Thank you for purchasing the PG-FP5 flash memory programmer.

This document describes specifications that have been added or changed, restrictions, and cautions on using the PG-FP5. Also see the user's manual of the PG-FP5 for cautions on using the PG-FP5.

No. 1 Modification of **Cancel** button specification

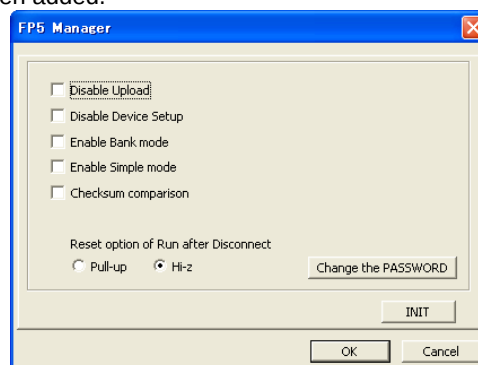
Description: The function of the **Cancel** button on the PG-FP5 main unit has been modified so that cancellation, which was applied to all commands, is only applied to the **Read** command.

Implementation: This item has been implemented in products with control code A (firmware: V1.01, FPGA: V1, GUI: V1.00).

No. 15 Addition of **Wide Voltage mode** function

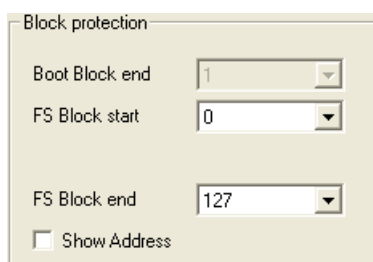
Description: The **Wide Voltage mode** check box has been added to the **Command options** area.

If this check box is selected, commands are executed in the wide voltage mode. If this check box is not selected, commands are executed in the full-speed mode. This check box is available when a device supporting this function is selected. For details about the wide voltage mode and full-speed mode, see the user's manual of each device.

Implementation: This item has been implemented in products with control code A (firmware: V2.02, FPGA: V2, GUI: V2.02).

No. 16 Change of layout in **Block protection** area

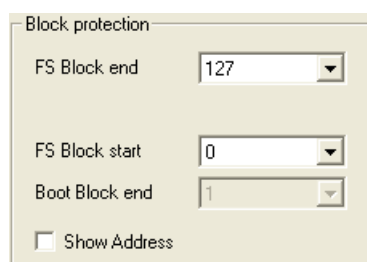
Description: The layout in the **Block protection** area has been changed.

Implementation: This item has been implemented in products with control code A (firmware: V2.02, FPGA: V2, GUI: V2.02).
